# Service Bulletin

DECEMBER 1959 NO. 350

STUDEBAKER-PACKARD CORPORATION

FIG. 1

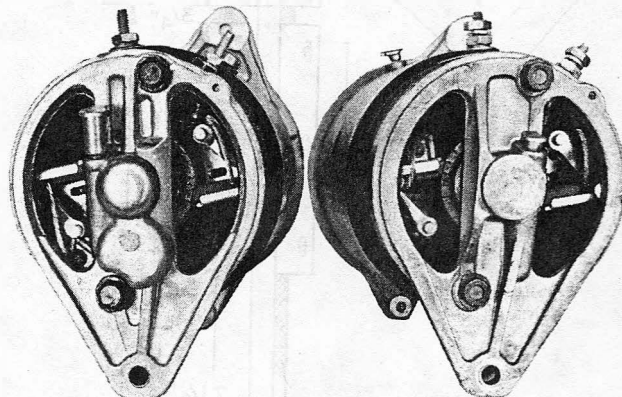
An improved design generator commutator end plate entered late production of 1959 - V8 models. The latest plate, illustrated on the left in Figure 1, can be identified by the larger oil reservoir located below the bearing area. This end plate, Part No. 1544188, available for service installation incorporates the larger type oil reservoir.

In case of commutator end plate bearing failure on early production 1959 models, in addition to installation of the end plate, Part No. 1544188, a new armature, Part No. 458827, should be installed, if there is any evidence of damage to the armature.

2 DOOR SEDAN  
FIG. 2

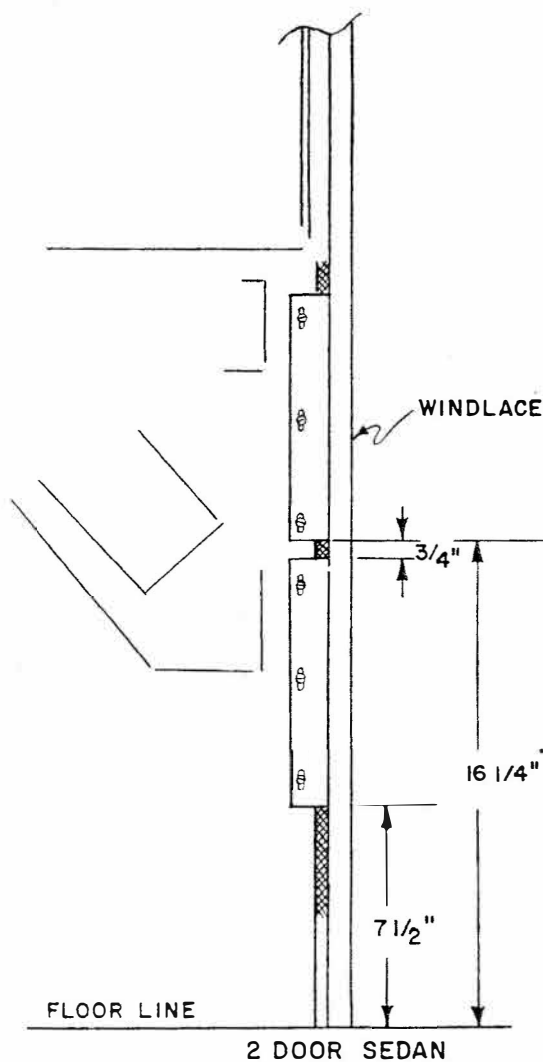
Remove the rear quarter trim panel and locate the lower edge of one plate 7 1/2" from the floor pan and the bottom of the second plate 16 1/4" from the floor pan. (See Fig. 2 .)

With the windlace properly positioned, install each retainer plate next to the windlace cord with 3 small sheet metal screws. The flanged edge of the retainer plate should face the door post. Make sure the retainer plates do not extend beyond the front edge of the door post.

4 DOOR SEDAN  
FIG. 3

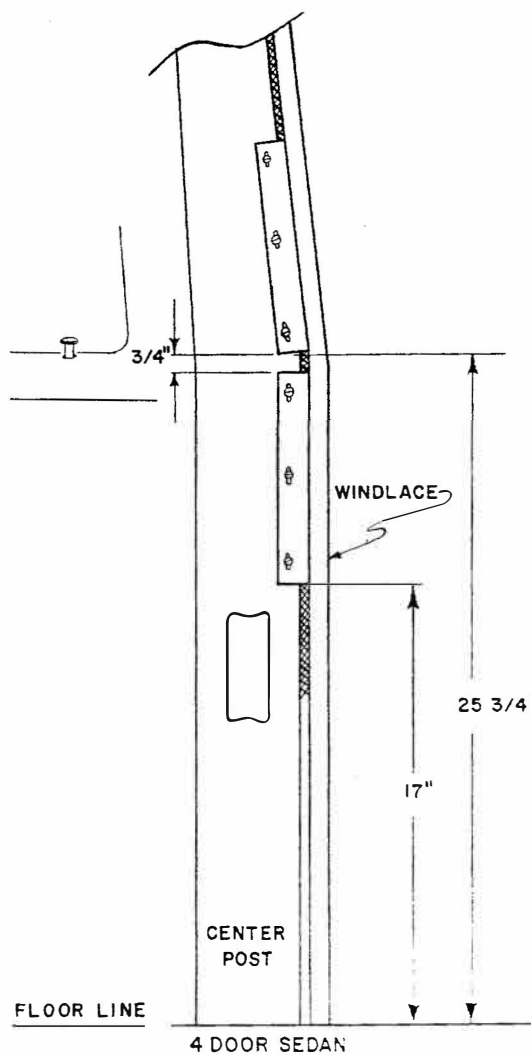
Carefully remove the door post trim panel by inserting a wide blade screw driver behind the trim panel at each drive nail location and pry the trim away from the post. The end of the screw driver should be placed between the drive nail trim retainer washers and the retainers in the post. The lower edge of one plate should be located 17" from the floor pan and the bottom of the second plate 25 3/4" from the floor pan. ( See Fig. 3 . )

FIG. 4

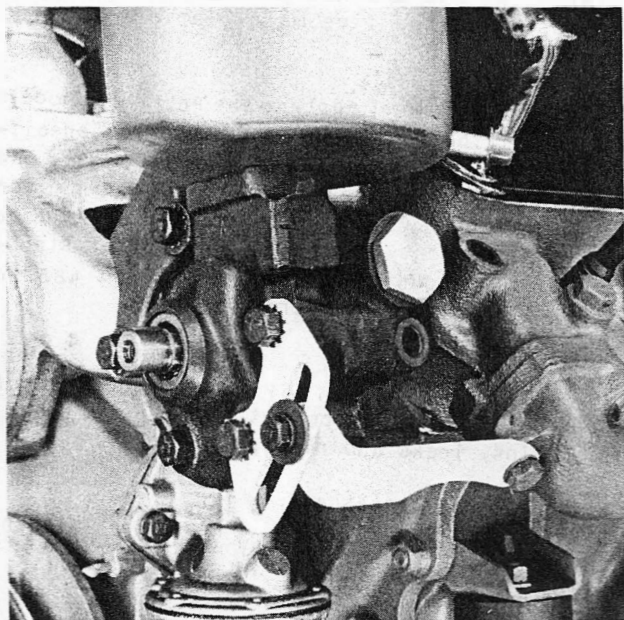
Remove the power steering pump pulley. Attach the bracket to the pump as shown in Fig. 4. The offset portion of the bracket

slide must be installed downward. Attach the brace to the bracket but do not tighten the retaining cap screw.

Remove the left front exhaust manifold-to-cylinder head cap screw and install the longer screw furnished in the kit, but do not tighten.

Install the pulley and drive belt and adjust belt tension. Then tighten the bracket-to-brace-to-manifold cap screws securely.
